Interactive comment on “Assessing the hydrologic restoration of an urbanized area via integrated distributed hydrological model” by D. H. Trinh and T. F. M. Chui

D. H. Trinh and T. F. M. Chui

Received and published: 28 July 2013

Fig. 1. Water balance aggregated over one year for different scenarios with a lower soil hydraulic conductivity

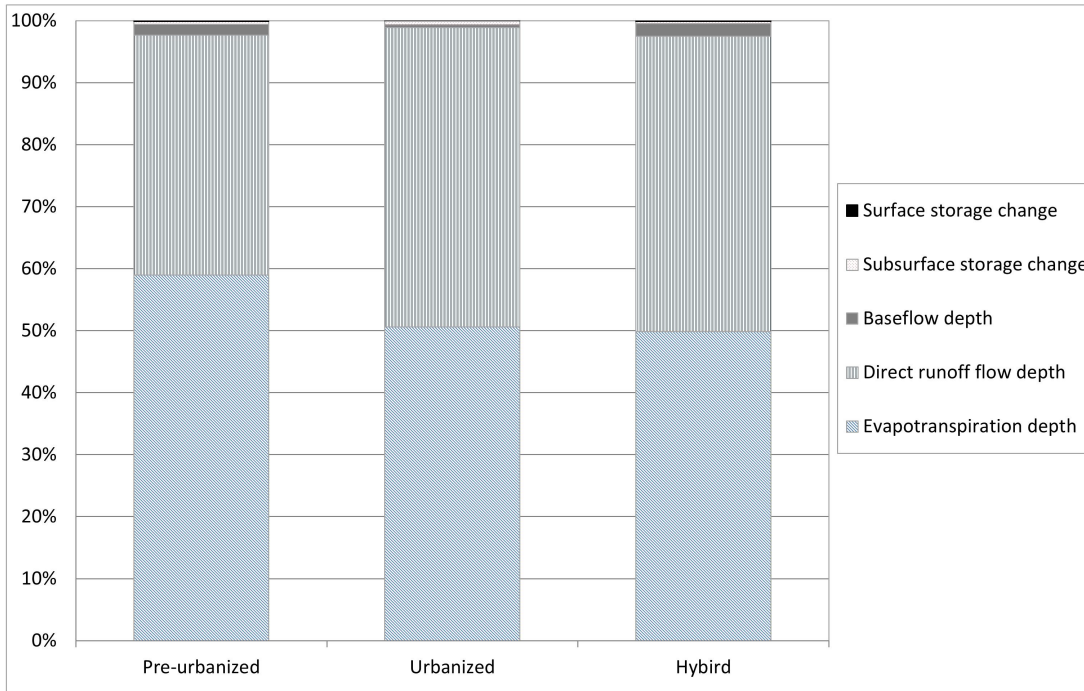
2. The main concern about the reviewed paper is related to an absolute lack of any observation data (apart from meteorological data), and all presented results and discussion are solely based on the model outcome. This is the main limitation of the suggested results: the model doesn't seem to be validated at all. In couple models, rainfall partitioning to recharge and runoff is depended on the soil properties, and it is very sensitive to unsaturated zone parameters. Incorrect partitioning, resulting from inadequate parameters selection propagates the error to simulated river flow. How much trust one can put in the model outcomes, when no evidences were offered on whether the model treats the rainfall partitioning correctly? Even in relative terms, the analysis of difference between selected scenarios on baseflow or peak flow could be wrong.

We understand and acknowledge that our models, without calibration and validation, are not producing the exact and precise responses of any particular system. Instead, we are hoping to develop general understandings on the overall effects of green structures using the physically based models with realistic choice of parameters, and that the generic results and insights are more widely applicable, as we have stated on p. 4105 lines 19-26 and on p. 4118 lines 1 to 5. We also agree with Dr. Barron that rainfall partitioning to recharge and runoff is sensitive to soil properties. We therefore simulate the different scenarios with a soil hydraulic conductivity that is one order of magnitude lower. For the aggregated water balance over one year (Fig.1), the rainfall partitioning still follows the same patterns as the original simulation. For example, when compared with the pre-urbanized scenario, there is still close to a 10% increase of direct runoff and 10% decrease in evapotranspiration in the urbanized and hybrid scenarios. There is also more baseflow in the hybrid scenario when compared to the urbanized one due to the green structures. In terms of peak outlet discharge (Fig.2), the low hydraulic conductivity leads to an increase of peak discharge by 50 m³/s in the pre-urbanized scenario. Similarly, the decrease in hydraulic conductivity also results in a higher peak discharge in the hybrid scenario. However, the amount of increase, 100 m³/s, is higher than pre-urbanized one. This is because the low hydraulic conductivity of the native soil not only reduces rainfall infiltration but also limit the exfiltration of the bio-retention system. The change in hydraulic conductivity however does not significantly affect the peaks in the urbanized scenario due to the low percentage of pervious area. Although the absolute values of peak discharges change with the hydraulic conductivity, the relative differences among the scenarios are still the same. In other words, there is still a drastic increase of peak discharge in the urbanized scenario and a partial recovery in the hybrid one. In conclusion, although the change in hydraulic conductivity leads to some changes in the model results in terms of the aggregated water balance as well as the absolute values of outlet peak discharge; the main observations of how urbanization influences hydrological conditions and how green structures restores it are still the same. Thus, we believe that the model outcomes are reliable for drawing the main

conclusions of this study.
